An investigation into a dropped fuel element incident at Chapelcross Nuclear Power Station

A report by HM Nuclear Installations Inspectorate

*Published by the Health and Safety Executive
February 2002*

Figure 3: Grab jaws

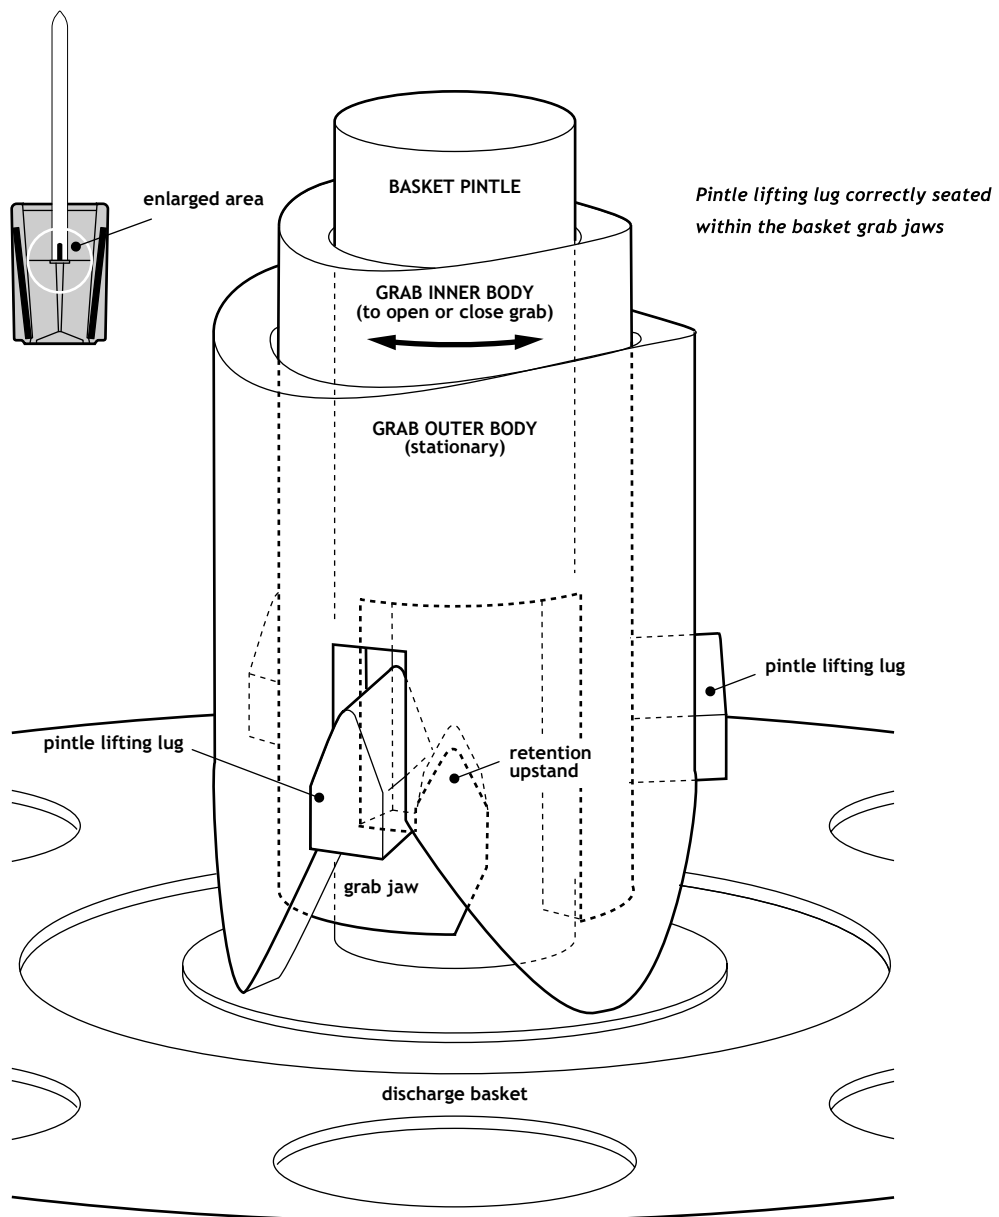
16. At the start of the process the operator lowers the basket grab down the discharge well onto the top of an empty fuel basket that has been placed at the bottom of the discharge shaft. Once the jaws of the grab are positioned around the lifting lugs of the discharge basket they are electrically driven into a closed position to latch the basket to the hoist. This is achieved by the counter rotation of the inner and outer cylinders. We found that there was no means of ensuring that the jaws properly latch onto the discharge basket pintle lifting lugs. Figure 3 shows the pintle lifting lug correctly seated within the basket grab jaws. Figure 4 shows a simulation of the grab jaws partially open. There is evidence from the as-found condition of the grab assembly to suggest that the jaws may not have been fully closed when the grab was connected to the basket at the start of operations.

17. Subsequent tests carried out by BNFL have shown that during closure of the grab, "spring back" can occur which can result in the jaws not being fully closed. These tests have shown that if there is only 25-50% relative movement between the inner and outer cylinders the discharge basket can still be lifted without the jaws being fully closed. The tests have also shown that there is a critical position where the jaws can spring open under the weight of the discharge basket. It is possible

that if the jaws of the grab had not been fully closed and were close to this critical position a jolt could cause them to spring open and allow the basket to drop.

(1) Install the Calder Hall “Top Hat” mechanism and train personnel in its operation and maintenance to prevent unplanned opening of the grab jaws (see paragraph 24).

Figure 5: Basket grab mechanical position indicator

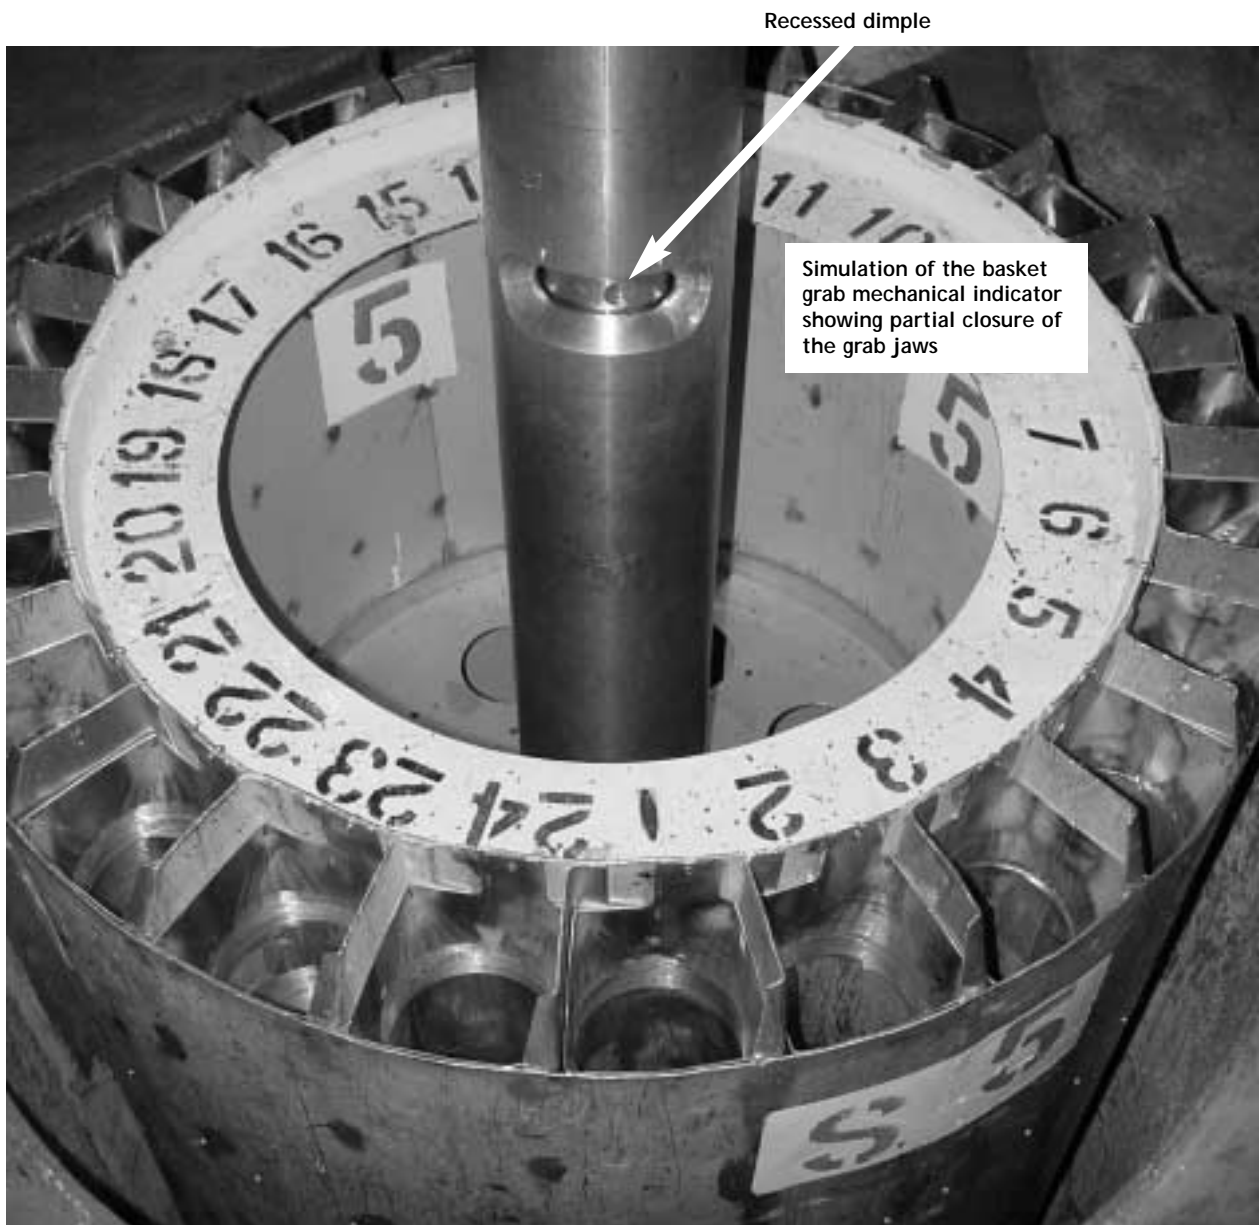
18. A mechanical indicator on the basket grab shows the relative position of the two concentric cylinders. The indication is provided by a slot cut into the outer cylinder and a recessed dimple in the surface of the inner cylinder. When the dimple is at one end of the slot the grab jaws are fully open and at the other end they are fully closed (Figure 5).

19. Our investigation found that it is only possible for the operator to attempt to confirm the position of the dimple within the slot, if it is aligned with either a camera mounted inside the discharge chamber (which has very limited capability), or an introscope which again has only a limited field of vision. This alignment with the camera does not routinely happen because the grab assembly is suspended on a long cable and freely rotates as it is raised and lowered. Interlocks prevent the operators entering the discharge chamber and visually confirming that the grab assembly had been correctly connected to the basket.

21. Our investigation concluded that safety would be improved by the installation of additional cameras within the discharge chamber to enable the operator to check and confirm that the basket grab is correctly latched before attempting to raise the basket up the discharge well.

Figure 6: Top view of discharge basket

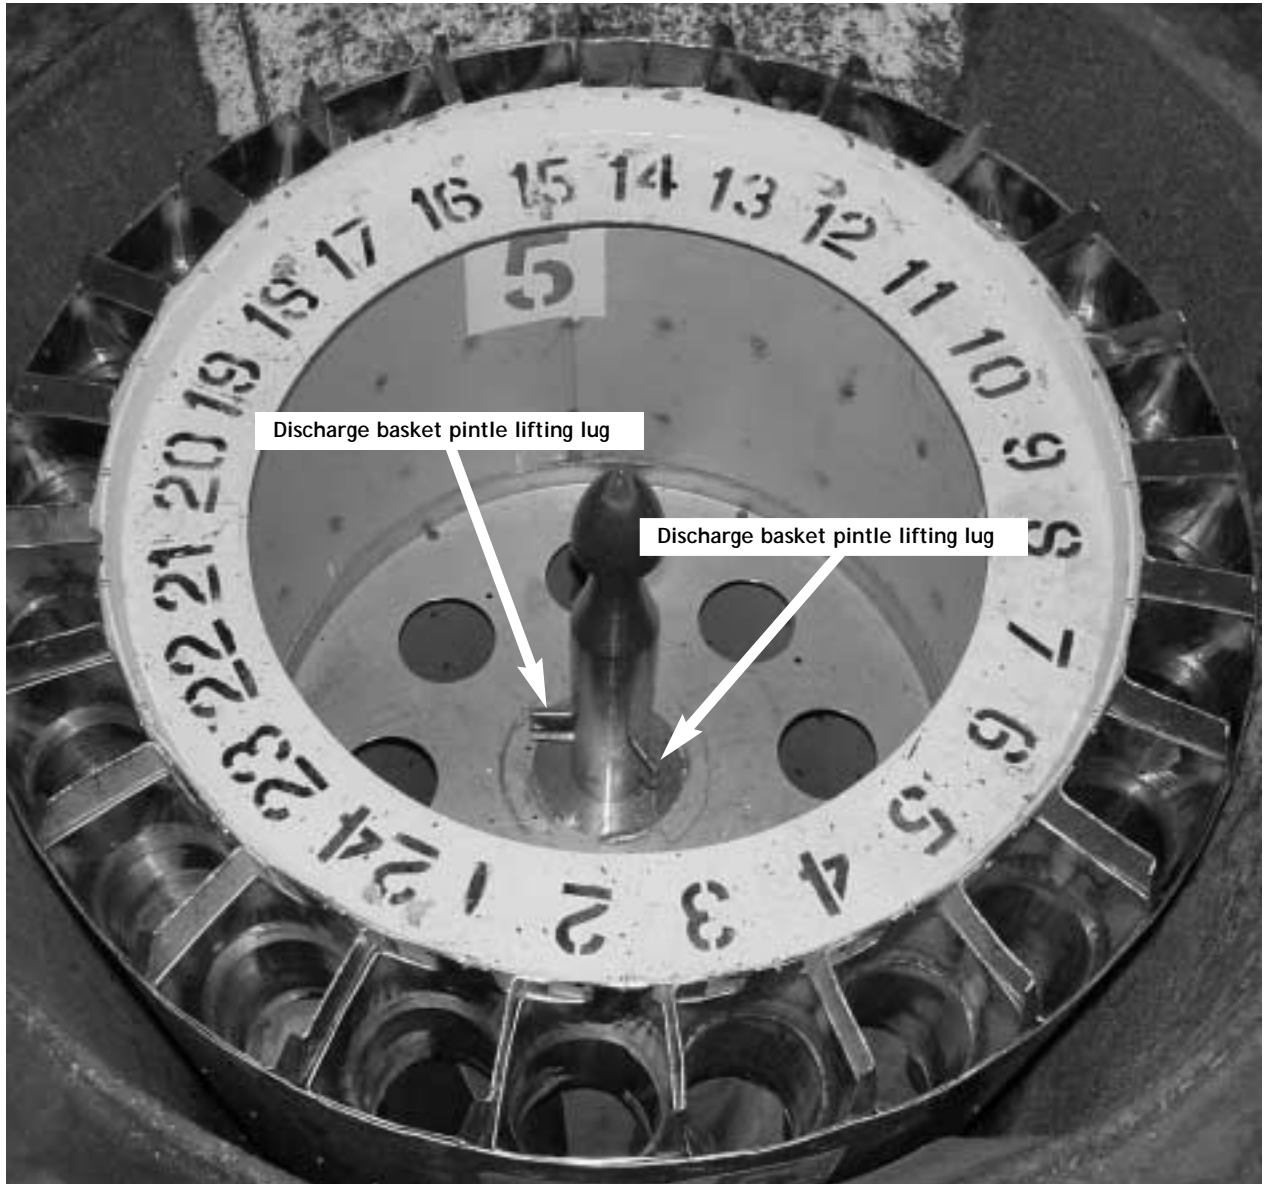
26. Once the operator has fitted the discharge machine door he moves the discharge machine from the traverser onto the pile cap. In order to load fuel elements into the discharge basket each of the basket’s twenty-four fuel element pockets are sequentially rotated to align with the fuel element grab. The indexing system used to rotate the basket through 360° imposes a jolt that is capable of causing relative movement between the inner and outer cylinders of the basket grab assembly and hence potential for the grab jaws to open. Under normal circumstances retention up-stands on the end of each grab jaw prevent this occurring because they locate against the discharge basket pintle lifting lugs (Figures 3, 4 and 6).

27. Once all the fuel elements have been loaded the basket is once again gradually indexed through 360° to allow an operator to look through the introscope on the side of the discharge machine to visually check that each fuel element is correctly aligned within its retention pocket. This rotation operation imposes a further jolt on the connection between the basket grab and discharge basket pintle lifting lugs.

Figure 7: Fuel elements inside discharge basket

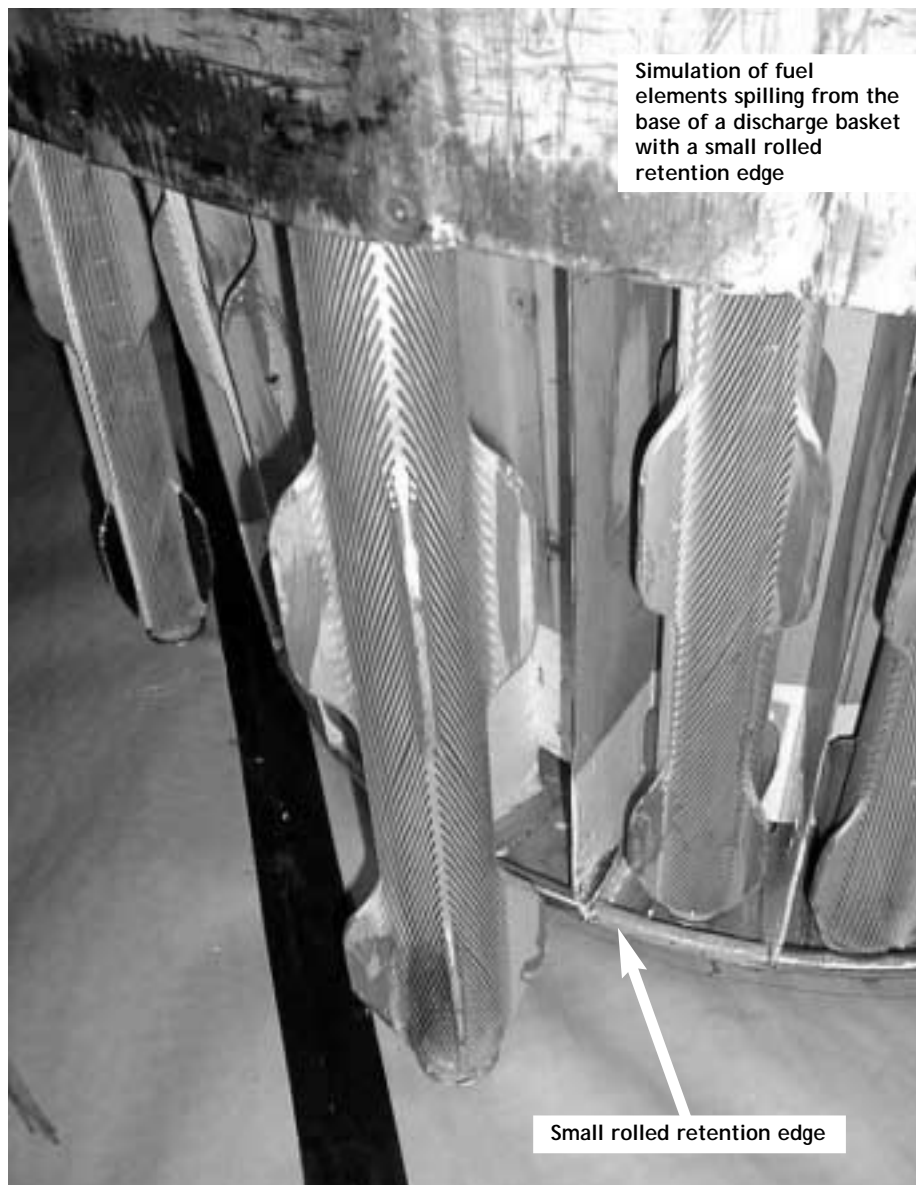
33. Our investigation also found that the discharge basket being used at the time of the incident only had a small rolled edge at its base which provided limited retention capability (Figure 7). This would not have been sufficient to prevent fuel

elements from jumping out of their recess as a result of the impact load from the basket striking the door of the hoist well. We conclude that this type of discharge basket should be withdrawn from service.

(5) Remove from service discharge baskets which only have a small rolled fuel retention lip (see paragraph 33).
